**BOARD OF ZONING APPEALS
CITY OF PRAIRIE VILLAGE
TUESDAY, JUNE 2, 2026
7700 MISSION ROAD
COUNCIL CHAMBERS
6:00 P.M.**

BZA2026-05 Variance for cumulative side setback
5009 W. 70th Street
Zoning: R-1B
Applicant: Scott McKenzie and Connie Link McKenzie

TO: Prairie Village Planning Commission
FROM: Chris Brewster, Multistudio, Planning Consultant
DATE: June 2, 2026, Board of Zoning Appeals Meeting

South Elevation 6
 1/8" = 1'-0"

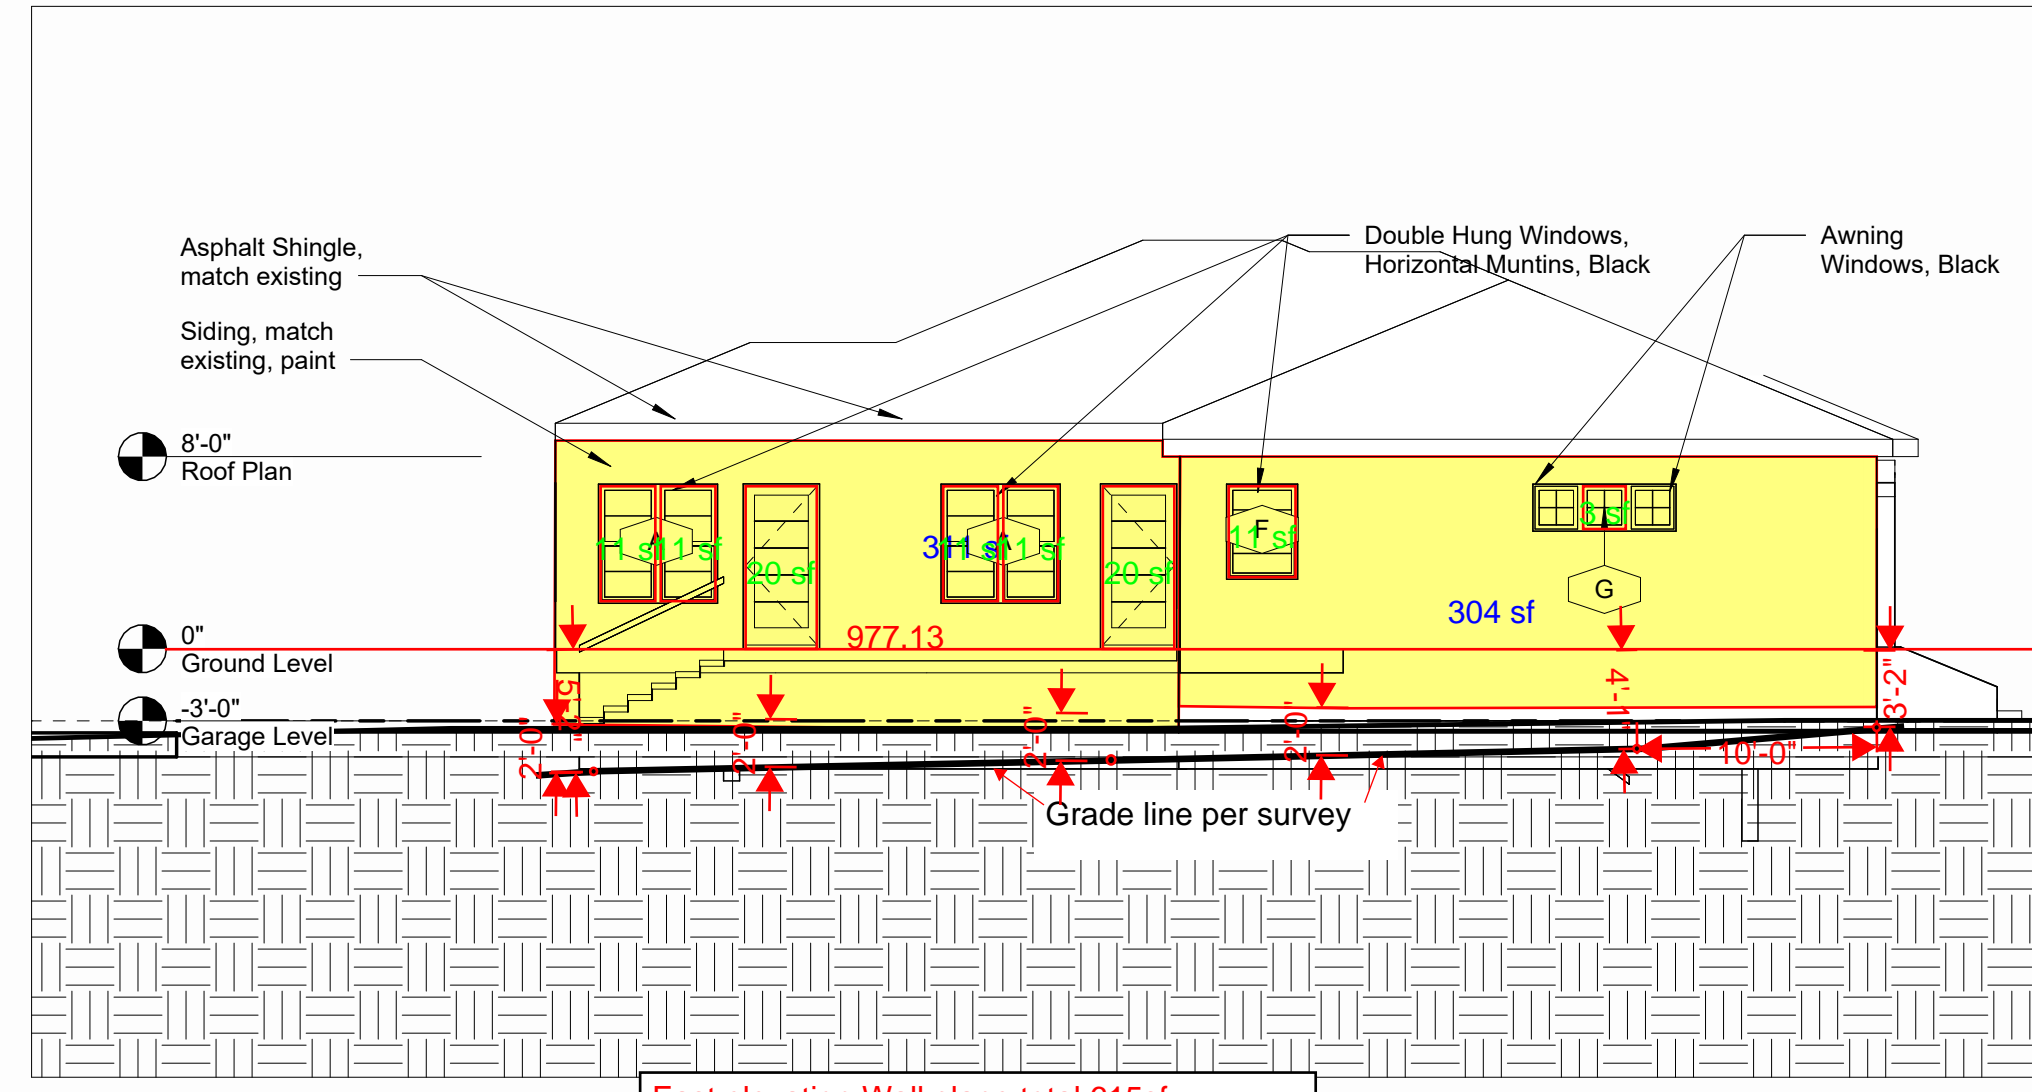
South elevation Wall plane total 366sf
 Varied wall massing under 500 feet OKAY
 Windows no trim 140sf or 38.25%
 Complies with PVZC 19.08.025 DG
 Calculated with siding lowered to less than 24" of exposed foundation walls .

East Elevation 2
 1/8" = 1'-0"

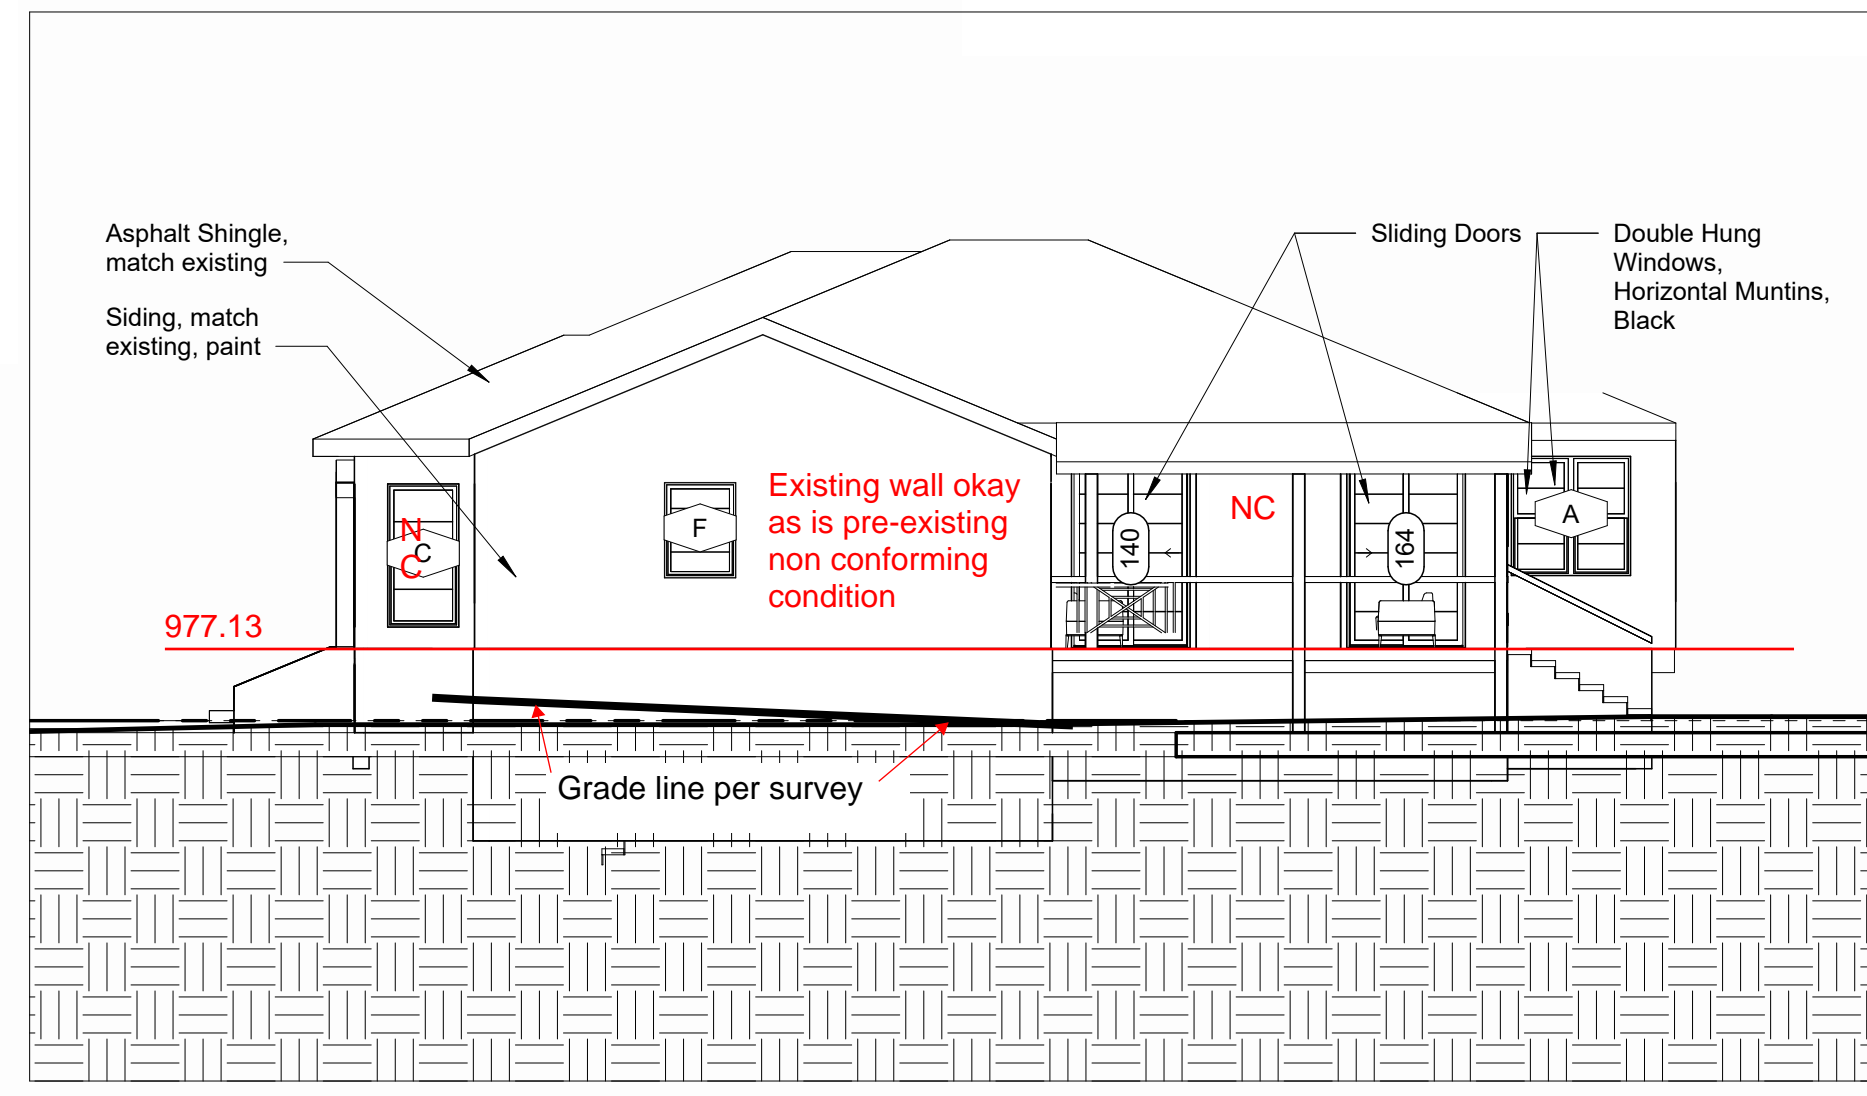
East elevation Wall plane total 615sf
 Varied wall massing 311 or 50.56%
 windows no trim 104sf or 16.91%
 Complies with PVZC 19.08.025 DG
 Calculated with siding lowered to less than 24" of exposed foundation walls .

North Elevation 5
 1/8" = 1'-0"

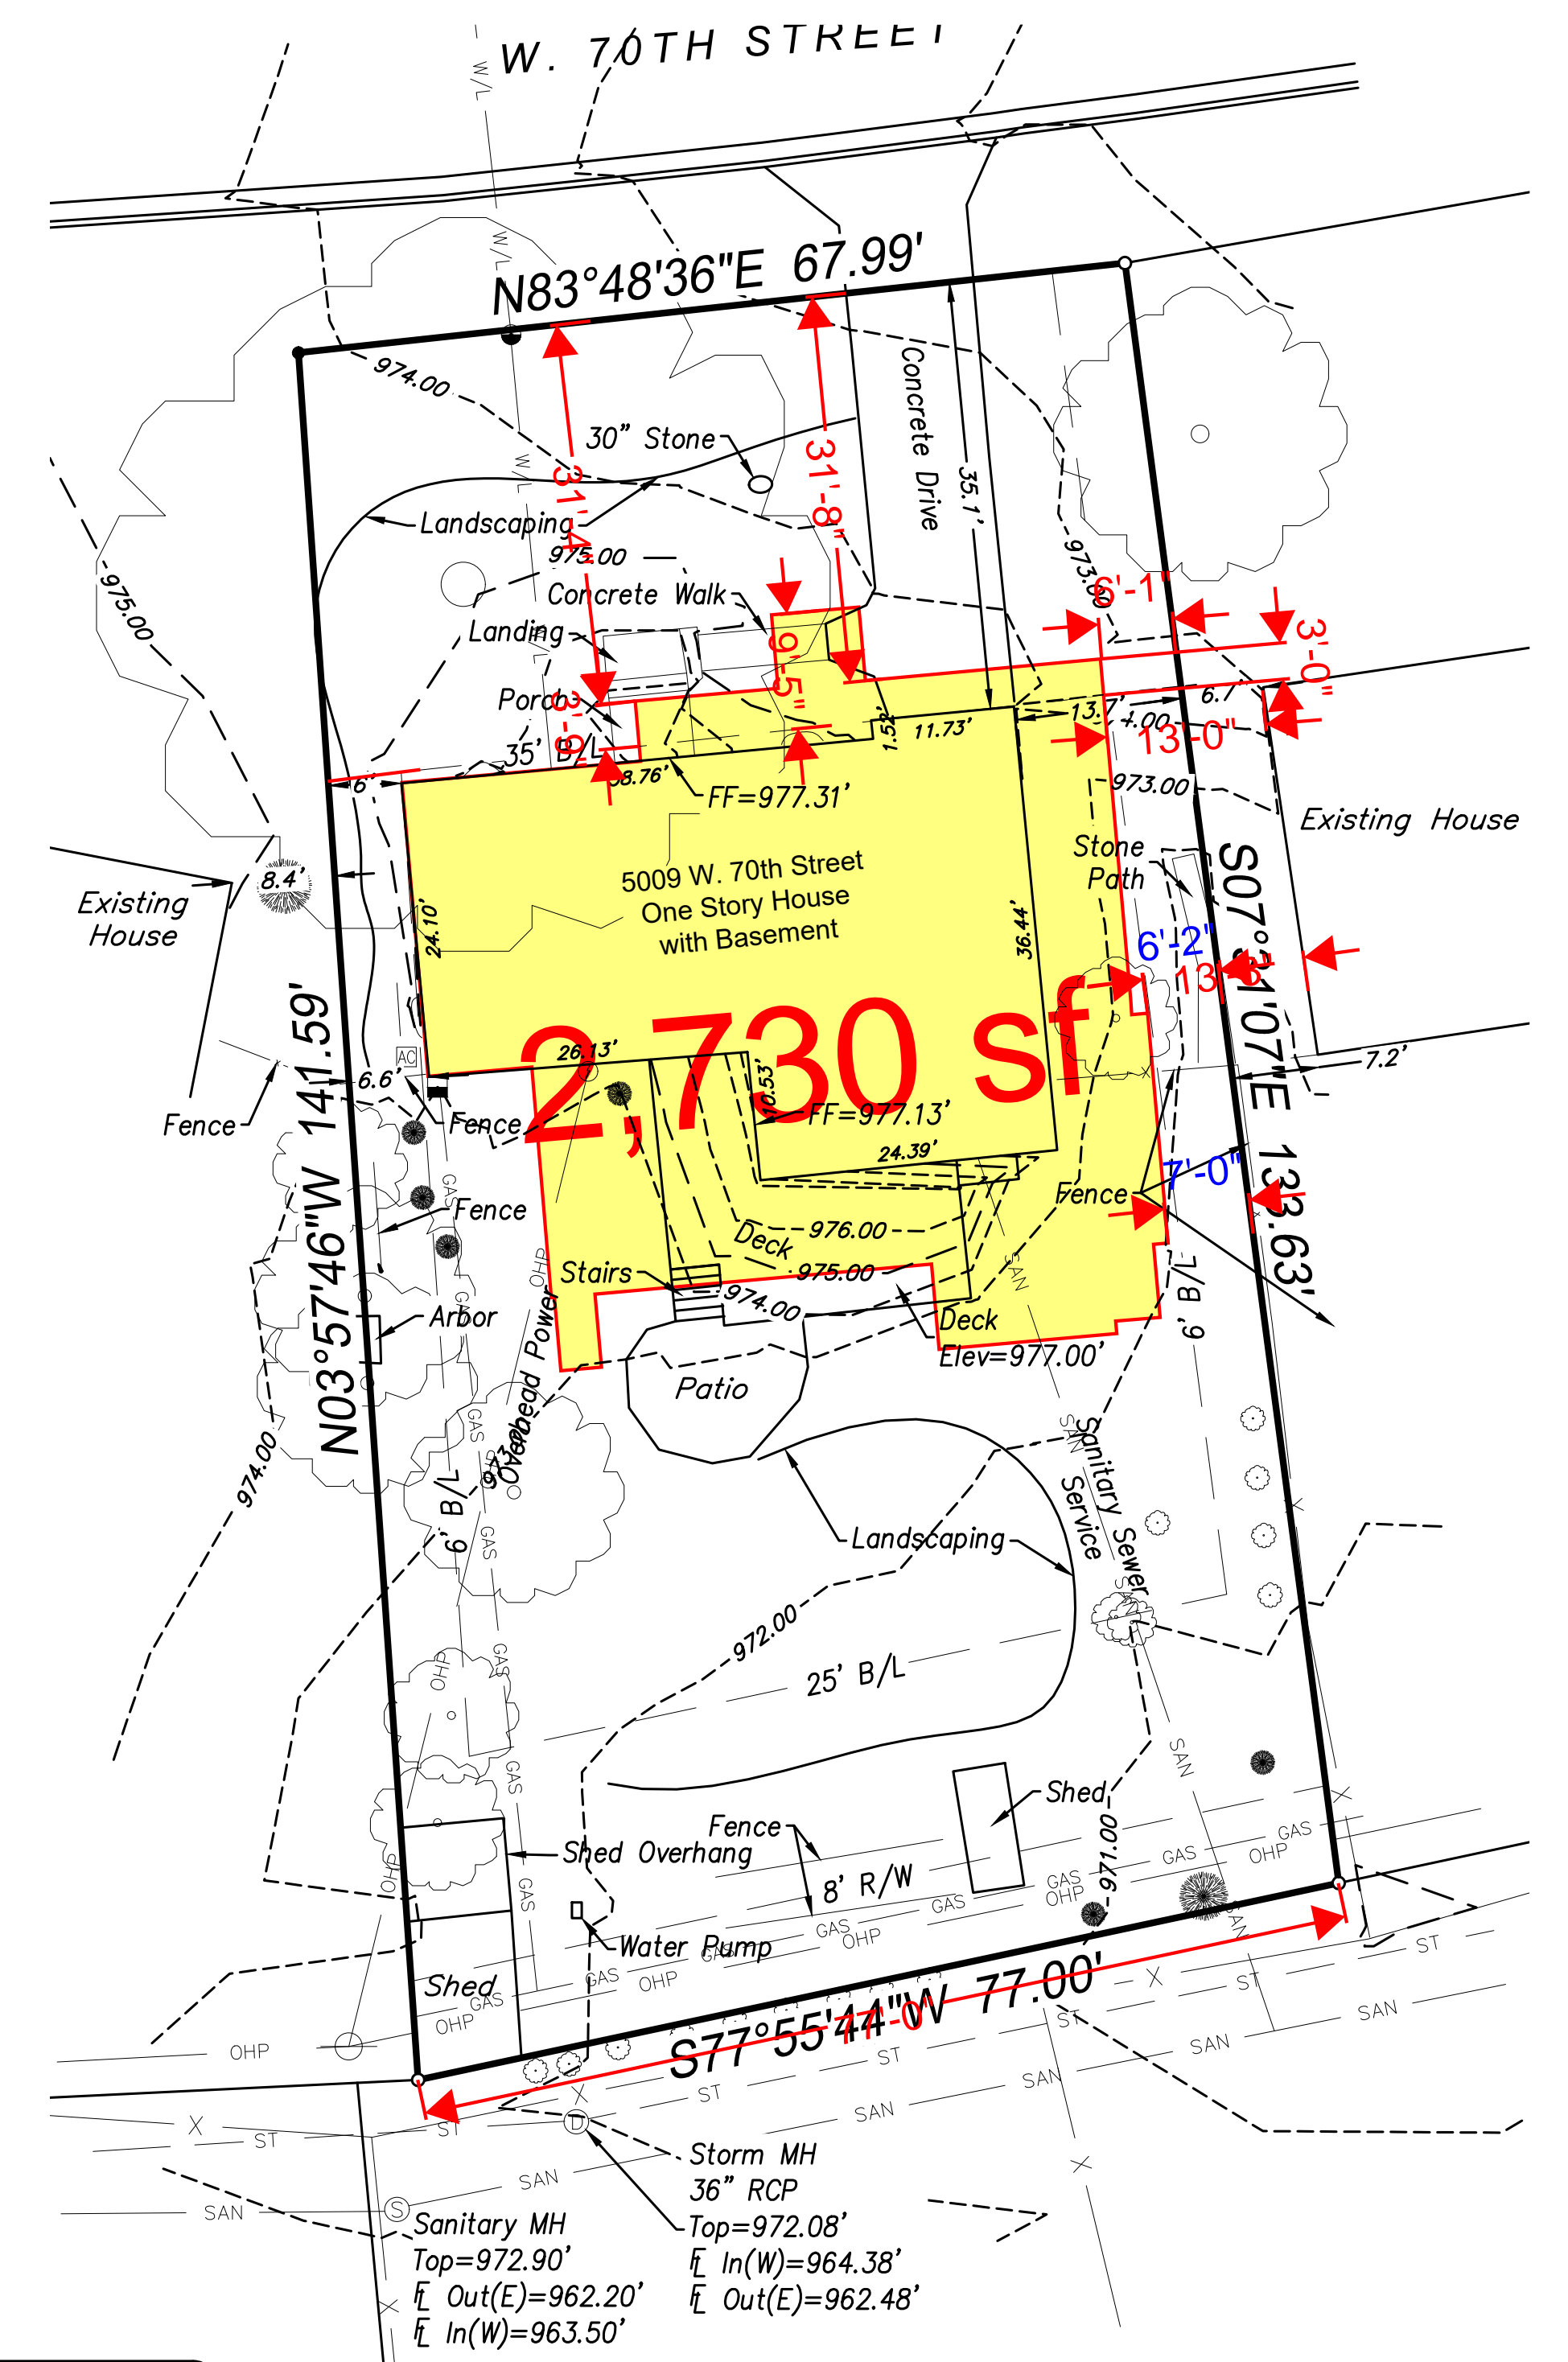
North elevation wall plane total 527sf
 Varied wall massing 157sf or 29.79%
 Garage width to Building width okay less than 24".
 Window + F doors 119sf or 22.58%
 Complies with PVZC 19.08.025 DG-except exposed foundation walls greater than 24".
